UNITED STATES PATENT AND TRADEMARK OFFICE

10/581,697

Office Action Summary	Application No. 10/581,697	Applicant(s) GSCHWEND, CHRISTIAN	
	Examiner BRADLEY H. DUCKWORTH	Art Unit 3632

DETAILED ACTION

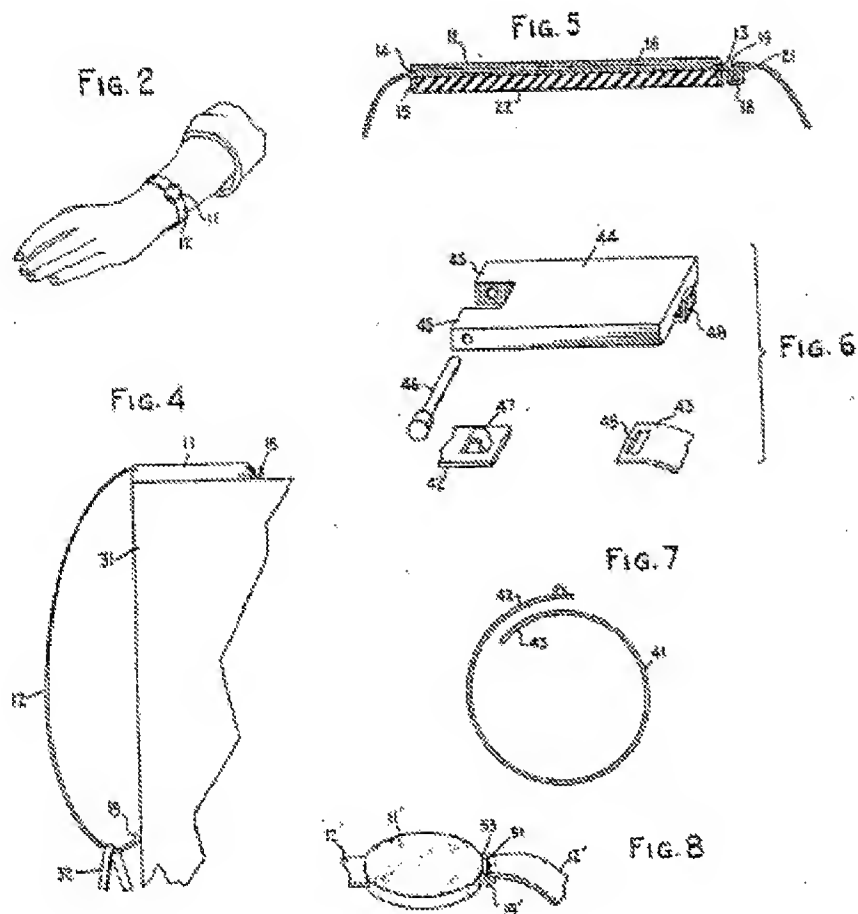
Claims 1,2,13 and 19 are rejected under 35 U.S.C. 102(b) as being anticipated by Montero(FR1015197). Referring to figures 4-6, Montero discloses a bag holder comprising a closed bracelet member which can be used to display precious stones. The bracelet having an open U-shaped position(figure 4) with an elastically resilient band made from spring steel having a first limb(12) that ends in a first end region(44) having a first end, and a second limb with an end region having an end(21) that curves back to the first limb, the limbs connected by an arch(bottom of loop), the first and second end regions being able to be spread apart in an open position(figure 4) and closed in a closed position(figure 5) where the second end region having a substantially planar portion(generally 43) which overlaps a substantially planar end portion of the first end region so that they are substantially parallel over the entire region of overlap(see figure 5). The device further having a friction pad layer(22) formed on an inner side of the band. As seen in figure 4, the holder first limb being positionable on a flat surface with the second end hanging down and having a distal end extending upwards forming a hook.

Applicant's arguments filed 1/26/09 have been fully considered but they are not persuasive. Applicant argues that Montero does not teach ends on the end regions, and that the end regions of Montero are not substantially parallel over the entire region of overlap. First there are clearly terminal ends on the end regions of the holder of Montero, and secondly as addressed in the previous action, the end regions of Montero as seen in figure 5 are substantially parallel over the entire region of overlap.

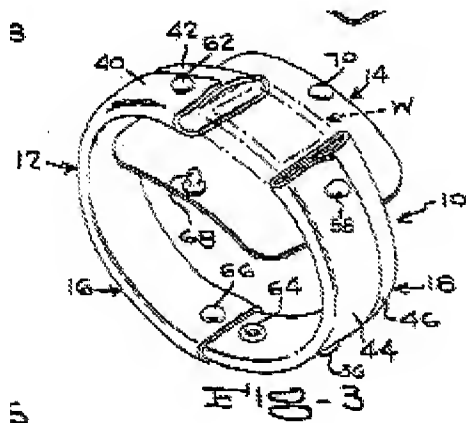
Claims 3-11 and 15-17 are rejected under 35 U.S.C. 103(a) as being unpatentable over Montero as applied to claim 1 above, and further in view of Cornett(US002998695). Montero discloses a support in the form of a bracelet as detailed above, however Montero does not disclose the use of a cover or coating in the form of a bag like member to encompass the band of the support. Cornett discloses a cover for a watch used to protect the enclosed watch from damage(C1 L9-15), comprising a bag like cover(see figure 3) that completely encompasses a watch, the cover having a closed end(at 66) and an open end having a bag opening(near 62) and a closure having a closure part, snap fasteners(68+70, which were assumed to be metal) that cover an end of the second end region of the second limb. First it would have been obvious to one of ordinary skill in the art at the time of invention to place such a cover

on the bracelet of Montero to protect the bracelet from damage. While Cornett discloses that the cover can be made from plastics, fabric or flexible metal(C2 L47-50), it would have been obvious to one of ordinary skill in the art at the time of invention to either place decorations, such as gems, on the outside of the cover, or to form the inside and outside of the cover out of different materials, as either modification would not affect the functionality, but rather only the appearance of the device, making such a change a matter of simple design choice.
